STATE OF MAINE
DEPARTMENT OF TRANSPORTATION
16 STATE HOUSE STATION
AUGUSTA, MAINE
04333-0016

December 28, 2006
Subject: **Topsham**
Pin No. 14062.11
Amendment No. 2

Work under this contract is generally described as the construction of the MaineDOT TOPSHAM HIGHWAY MAINTENANCE GARAGE

TITLE
BUILDING BOLLARD PLAN & DETAILS

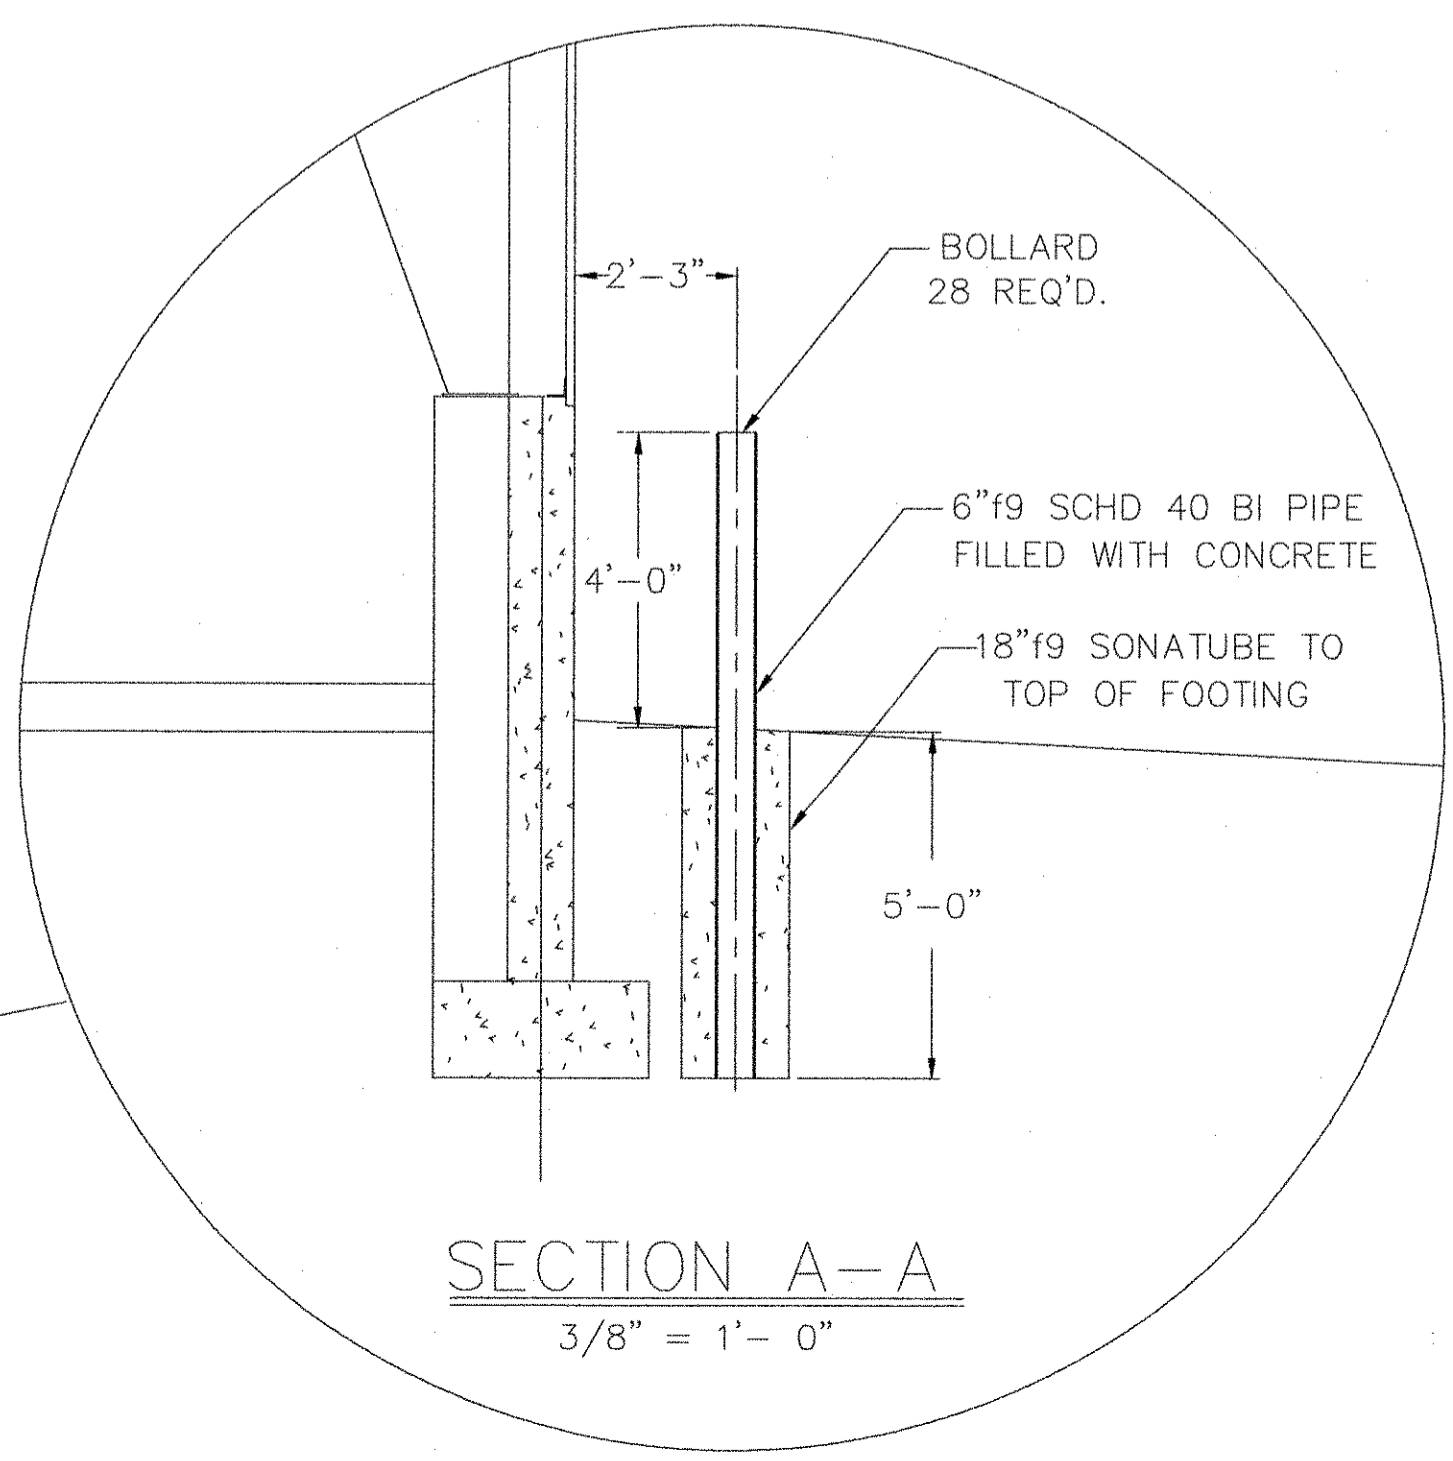
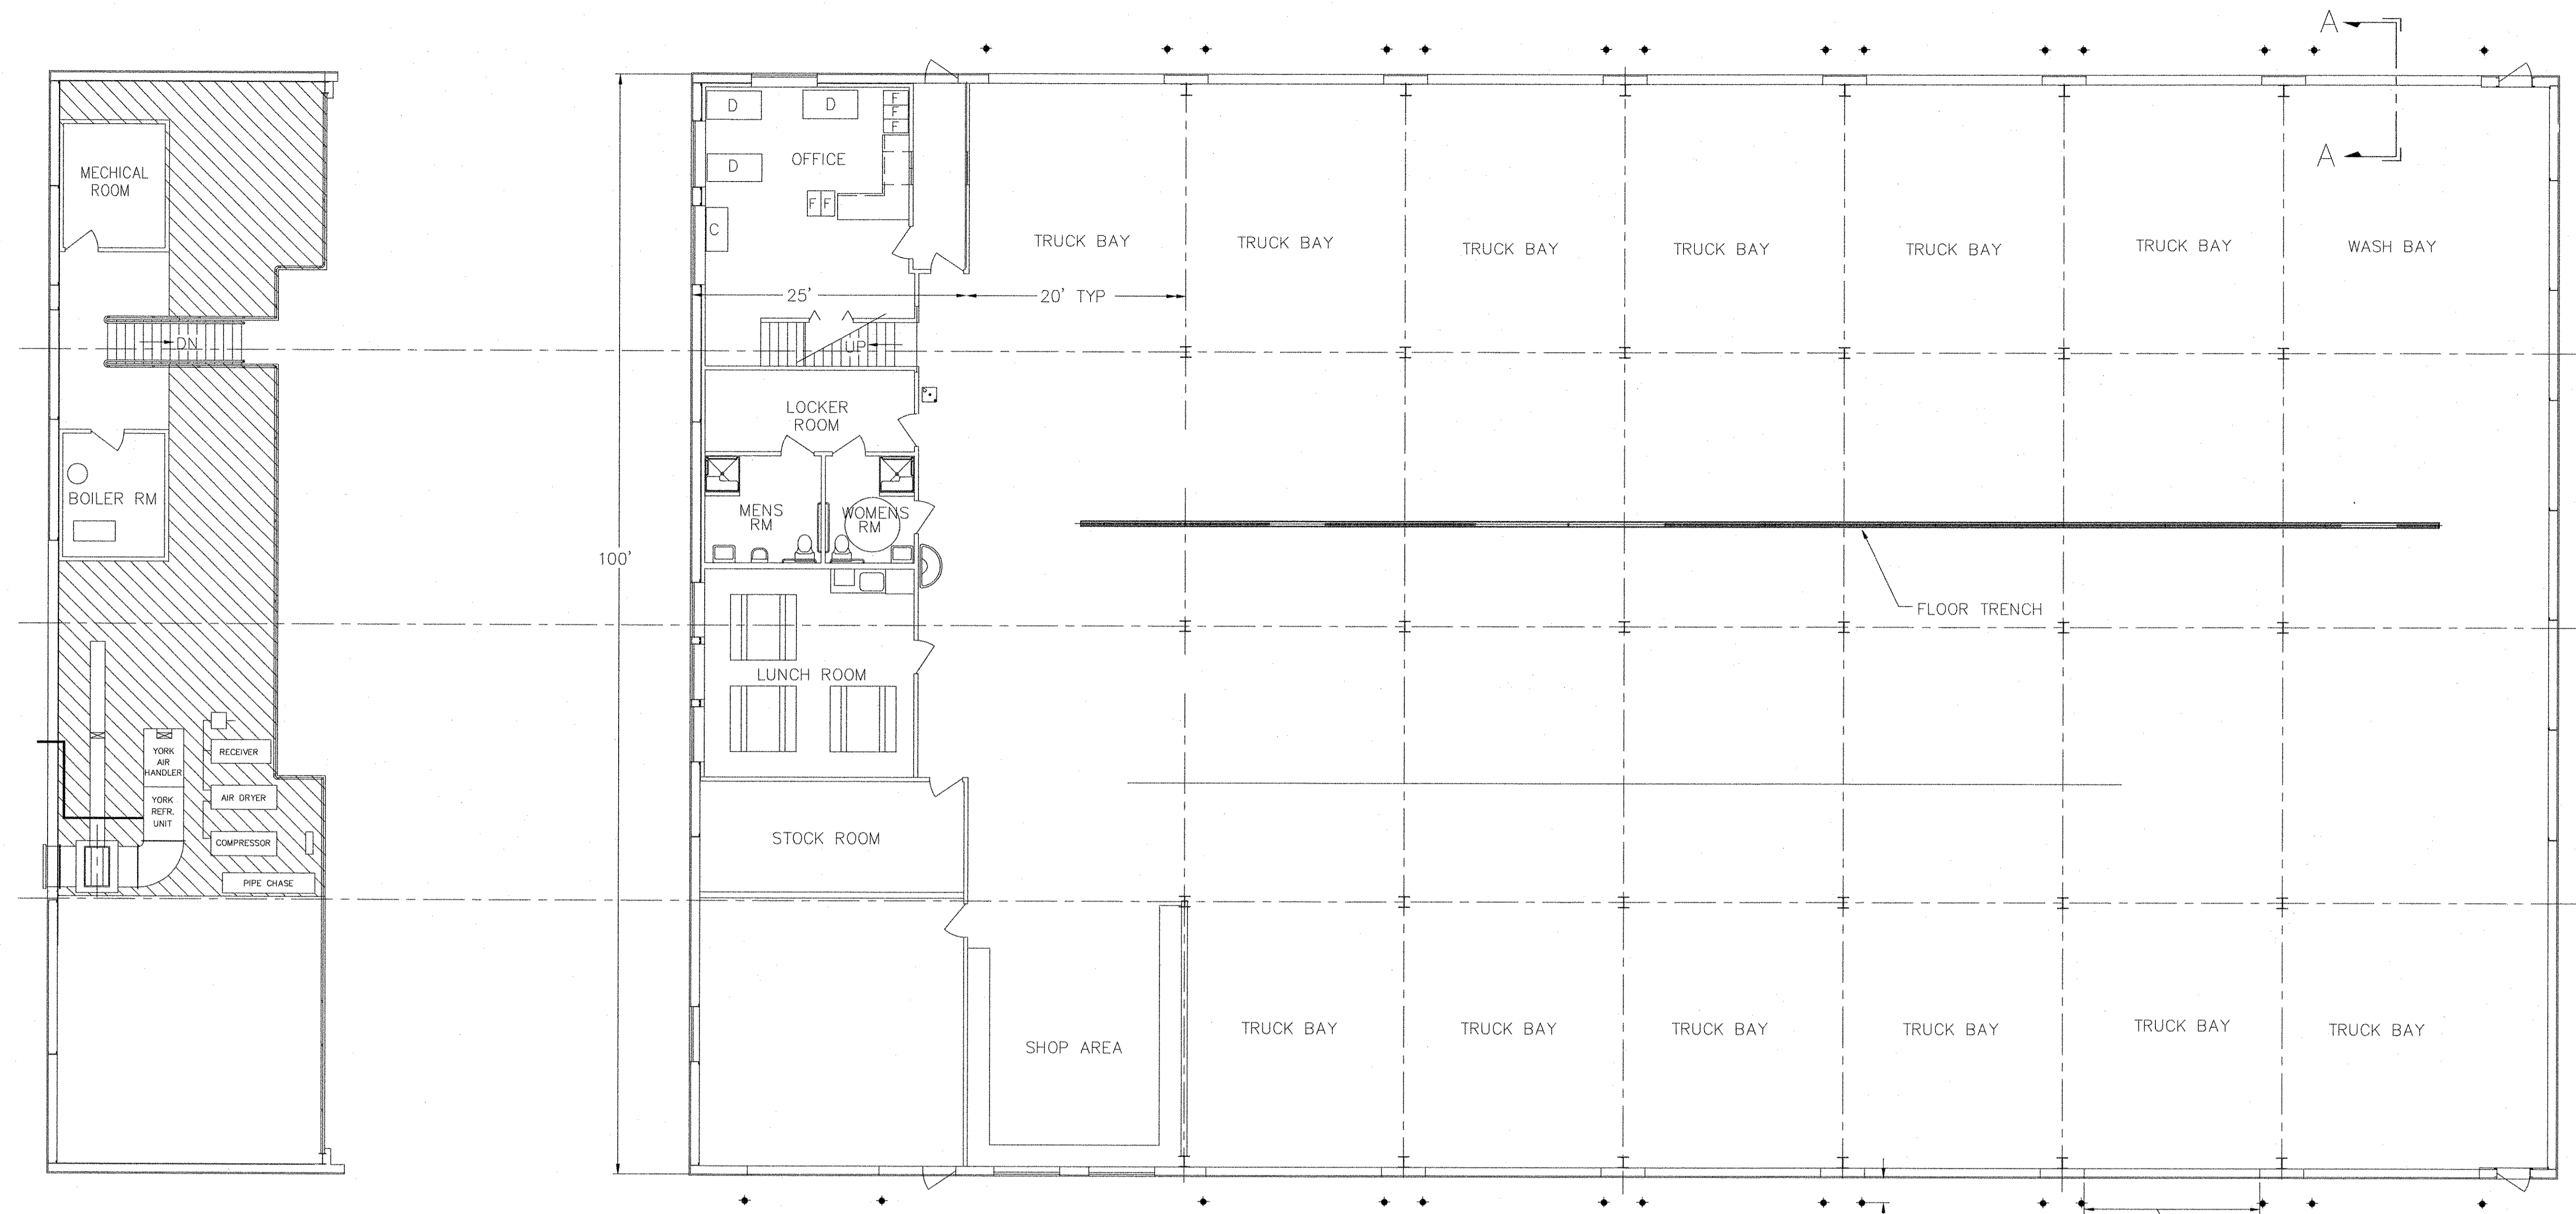
Question: Drawing A-7 Section A-A calls for 26 bollards required, the actual count is 28 on that drawing. Which is correct?

Response: Drawing A-7 has been removed and replaced by the attached plansheet A-7A, and the bollard quantity has been changed to 28.
